CITY OF
West Linn

**STAFF REPORT
FOR THE HISTORIC REVIEW BOARD**

FILE NUMBER: DR-23-01

REQUEST: Provide a recommendation to the Planning Commission regarding a proposed Design Exception to exceed the maximum height limit of two stories, as part of a Class II Design Review at 1919 & 1949 Willamette Falls Drive.

1 GROUND FLOOR PLAN + WILLAMETTE FALLS DRIVE ELEVATION

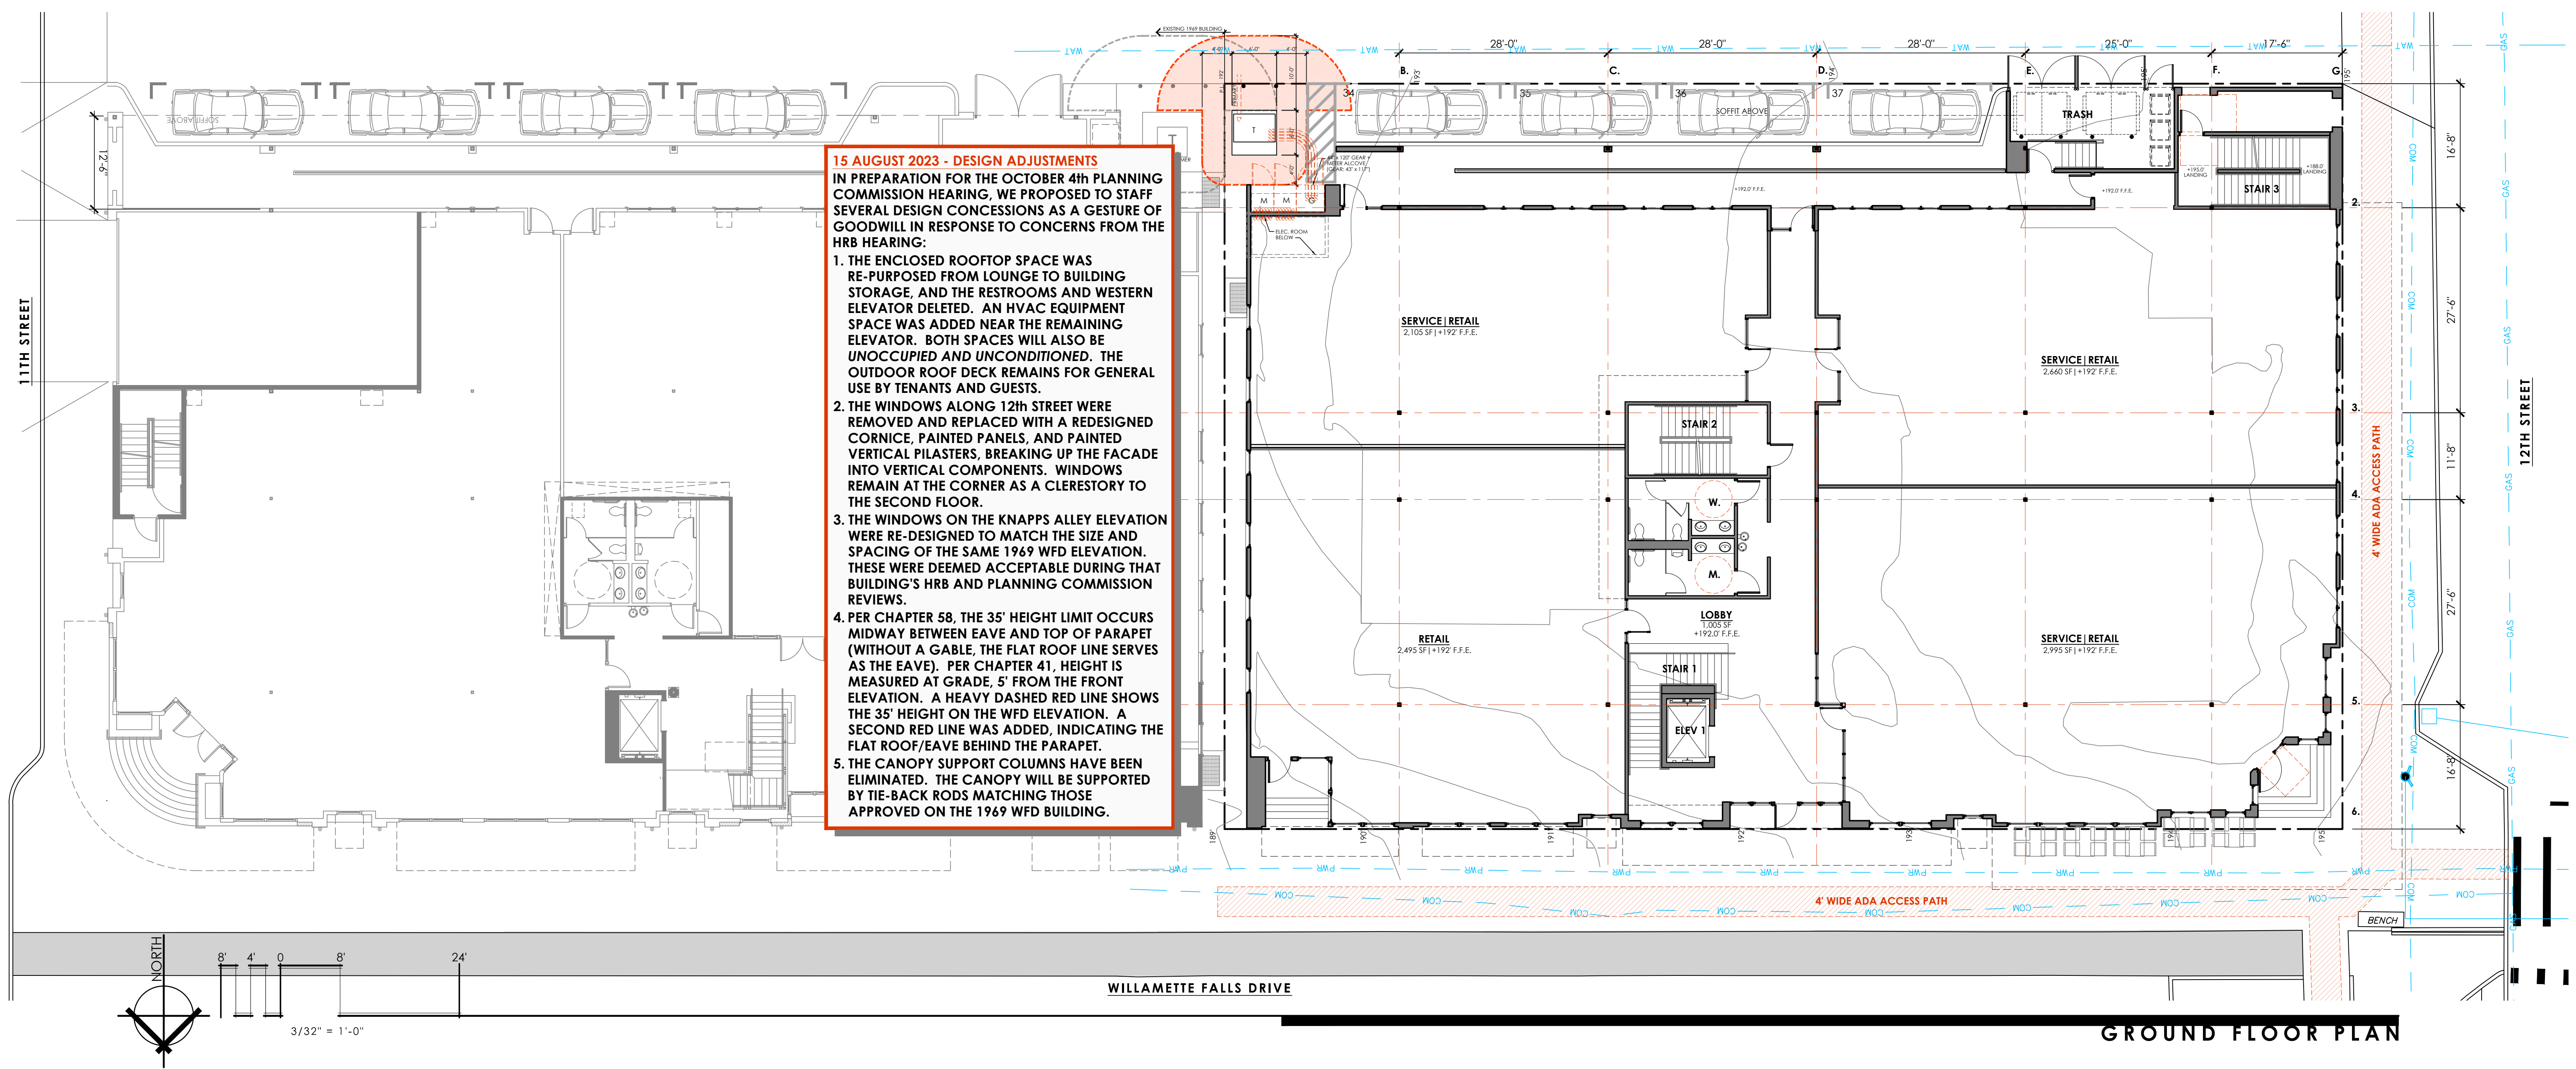
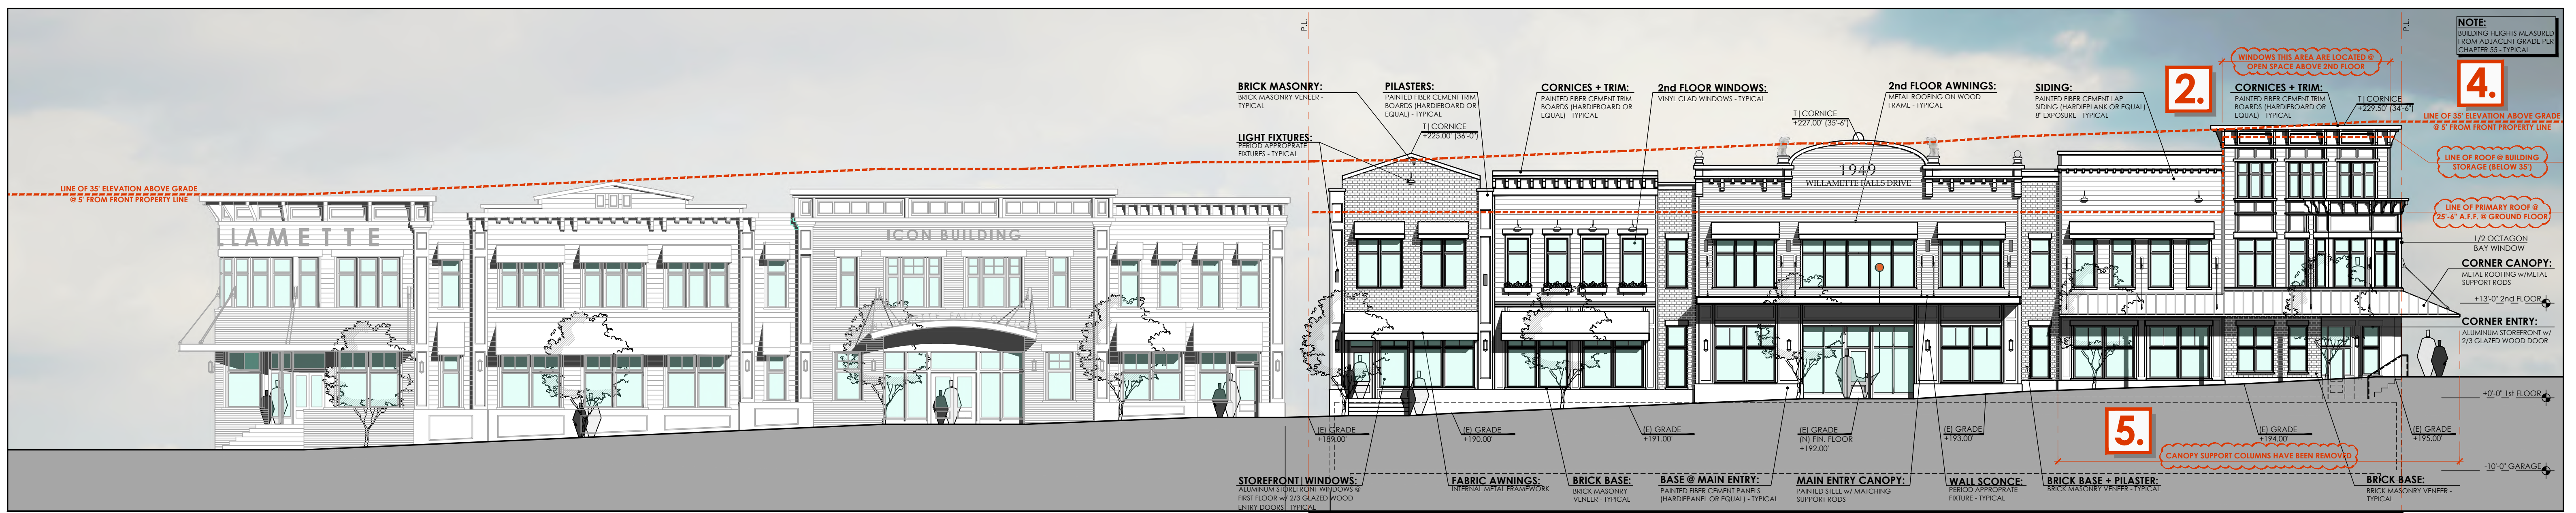
1. THE ENCLOSED ROOFTOP SPACE WAS RE-PURPOSED FROM LOUNGE TO BUILDING STORAGE, AND THE RESTROOMS AND WESTERN ELEVATOR DELETED. AN HVAC EQUIPMENT SPACE WAS ADDED NEAR THE REMAINING ELEVATOR. BOTH SPACES WILL ALSO BE UNOCCUPIED AND UNCONDITIONED. THE OUTDOOR ROOF DECK REMAINS FOR GENERAL USE BY TENANTS AND GUESTS.

2. THE WINDOWS ALONG 12th STREET WERE REMOVED AND REPLACED WITH A REDESIGNED CORNICE, PAINTED PANELS, AND PAINTED VERTICAL PILASTERS, BREAKING UP THE FACADE INTO VERTICAL COMPONENTS. WINDOWS REMAIN AT THE CORNER AS A CLERESTORY TO THE SECOND FLOOR.

3. THE WINDOWS ON THE KNAPPS ALLEY ELEVATION WERE RE-DESIGNED TO MATCH THE SIZE AND SPACING OF THE SAME 1969 WFD ELEVATION. THESE WERE DEEMED ACCEPTABLE DURING THAT BUILDING'S HRB AND PLANNING COMMISSION REVIEWS.

4. PER CHAPTER 58, THE 35' HEIGHT LIMIT OCCURS MIDWAY BETWEEN EAVE AND TOP OF PARAPET (WITHOUT A GABLE, THE FLAT ROOF LINE SERVES AS THE EAVE). PER CHAPTER 41, HEIGHT IS MEASURED AT GRADE, 5' FROM THE FRONT ELEVATION. A HEAVY DASHED RED LINE SHOWS THE 35' HEIGHT ON THE WFD ELEVATION. A SECOND RED LINE WAS ADDED, INDICATING THE FLAT ROOF/EAVE BEHIND THE PARAPET.

5. THE CANOPY SUPPORT COLUMNS HAVE BEEN ELIMINATED. THE CANOPY WILL BE SUPPORTED BY TIE-BACK RODS MATCHING THOSE APPROVED ON THE 1969 WFD BUILDING.
